# DEVELOPMENT REVIEW COMMITTEE (DRC) COMMENT REPORT

MEETING DATE:	December 10, 2019
PROPERTY OWNER:	7-Eleven Inc.
APPLICANT/AGENT:	Bowman Consulting
PROJECT NAME:	IHOP Restaurant
CASE NUMBER:	PLN-SITE-19110001
REQUEST:	Site Plan Level II Review: 3,767 Square Foot Restaurant within 100 Feet of Residential
LOCATION:	2900 W Broward Boulevard
ZONING:	Boulevard Business (B-1)
LAND USE:	Commercial
CASE PLANNER:	Tyler LaForme

## Case Number: PLN-Site-19110001

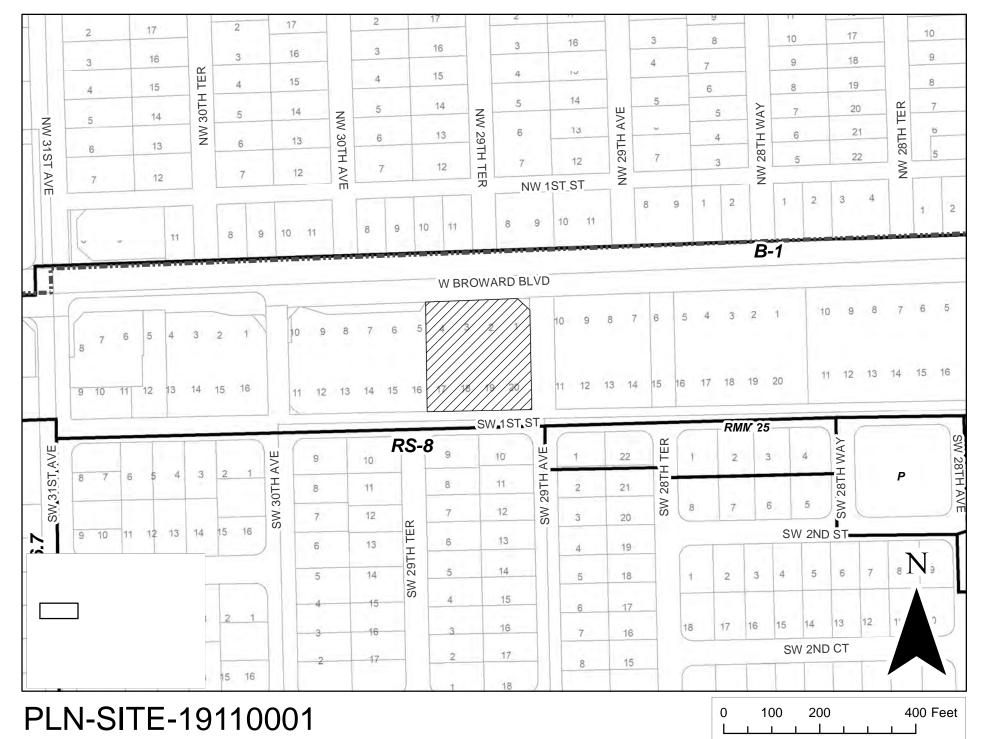
- 6) The building design and style should contain colors and materials reflective of the newer development along Broward Boulevard with increased transparency fronting the east, west, and north property lines. See images below for reference.
